JOB NO. MA24-04

LAHAINA SMALL BOAT HARBOR WATER SYSTEM LEAK ASSESSMENT AND REPAIR LAHAINA, MAUI, HAWAII

NOTE: THESE AS-BUILT PLANS HAVE BEEN MARKED UP TO SHOW THE SCOPE OF WORK FOR WATER SYTEM LEAK ASSESSMENT, PRESSURE TESTING, REPAIR AND NEW WATER SYSTEM WORK.

14+00

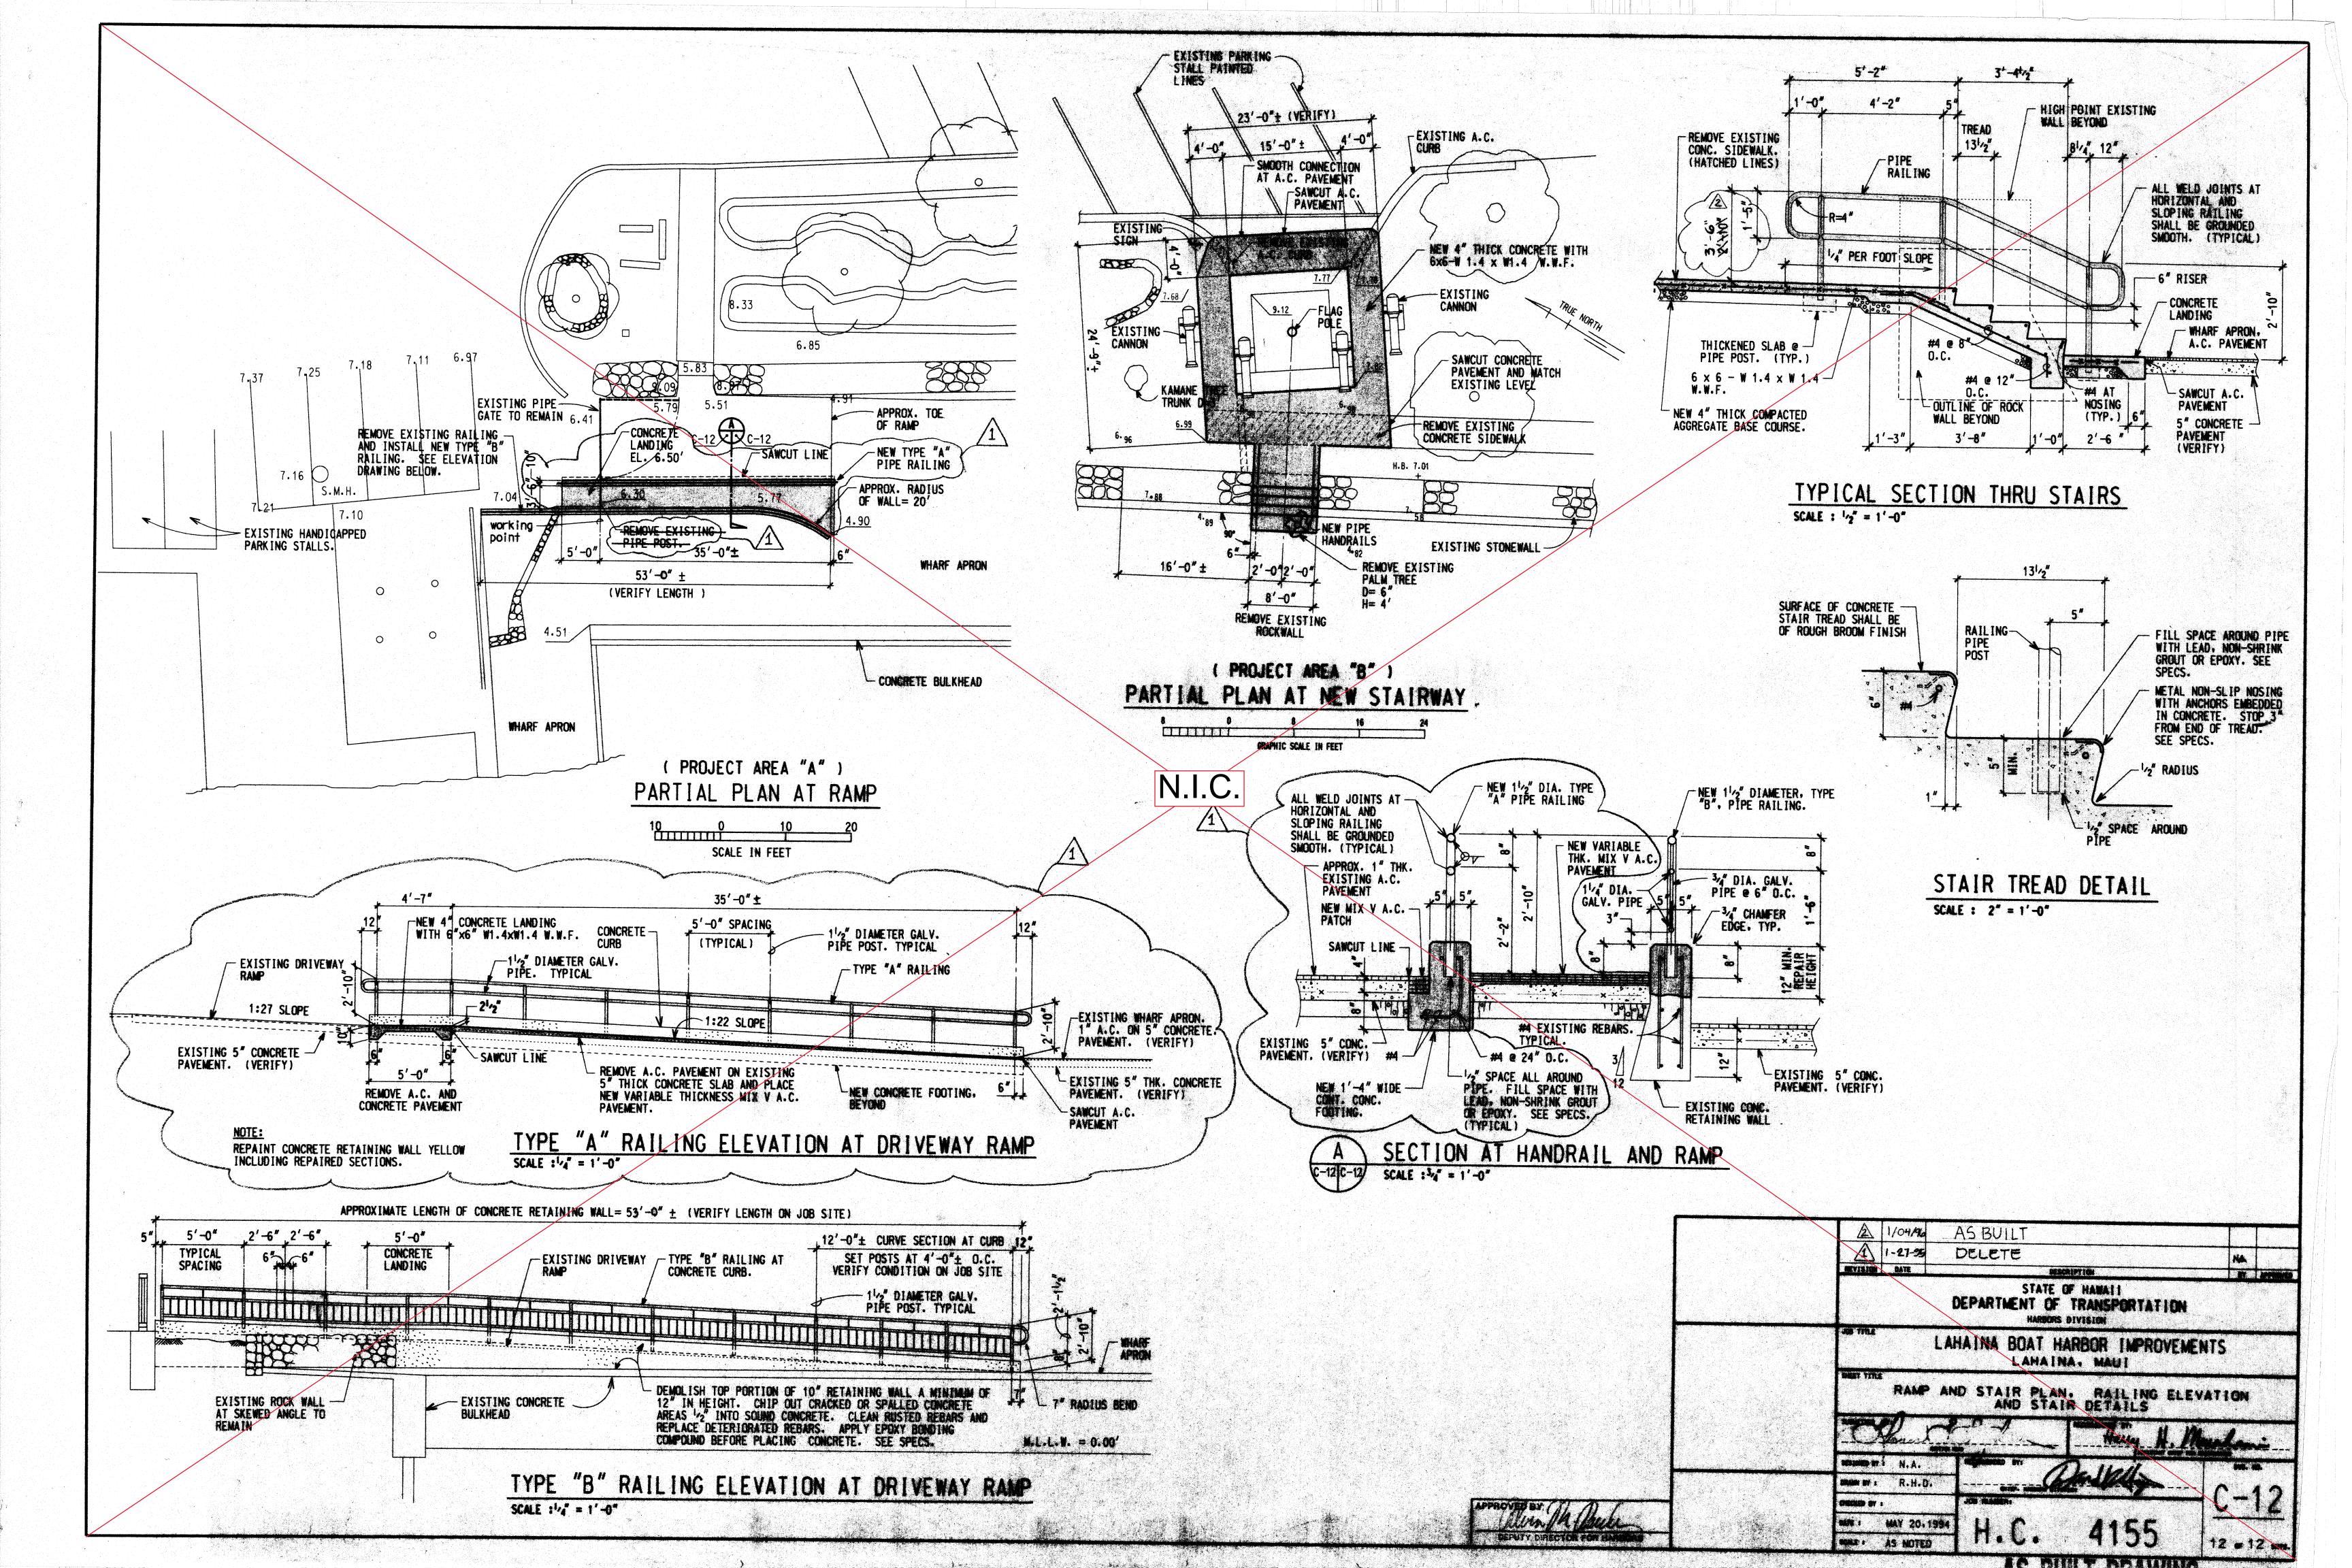
(1) EXPOSE EX. 6" D.I. FH LATERAL, CUT 4' FROM EX. FH, INSTALL NEW 6" CAP AŇD CONCRETE THRUST BLOCK FOR PRESSURE TESTING. INSTALL NEW FH PER DETAIL.

2 EXPOSE EX. 3" COPPER FIRE HOSE CABINET LATERAL, CUT 2' FROM EX. STANDPIPE, INSTALL NEW 3" CAP, AND CONCRETE THRUST BLOCK FOR PRESSURE TESTING. REMOVE EX. CONCRETE SLAB AND BOLLARDS WHERE APPLICABLE. INSTALL NEW FIRE DEPARTMET CONNECTION PER DETAIL.

(3) INSTALL NEW CLEANOUT PER DWS STD. DTL. V21 AT END OF EX. 12" D.I. WATERLINE.

4 INSTALL NEW CLEANOUT ON NEW 2" COPPER WATERLINE "B": 1 EA. 2" COPPER 1/4 BEND, 2" COPPER VERT. RISER PIPE (LENGTH AS REQ'D), AND 2" BRONZE BALL VALVE IN TYPE "X" METER BOX.

WATERLINE "B": INSTALL NEW 2" COPPER WATERLINE (700 LF) WITH 1/8 BENDS, 6' OFFSET FROM FACE OF CONC. BULKHEAD AS SHOWN. PROVIDE MIN. 1" TEMP. CONNECTION ON SOUTH END AND 2" CAP ON NORTH END FOR PRESSURE TESTING, INCLUDING ALL NEC. PIPING, FITTINGS, SHUTOFF VALVES, AND APPURTENANCES. RESTORE A.C. PAVEMENT AS NEC. SEE SHEET C-8 FOR CONT
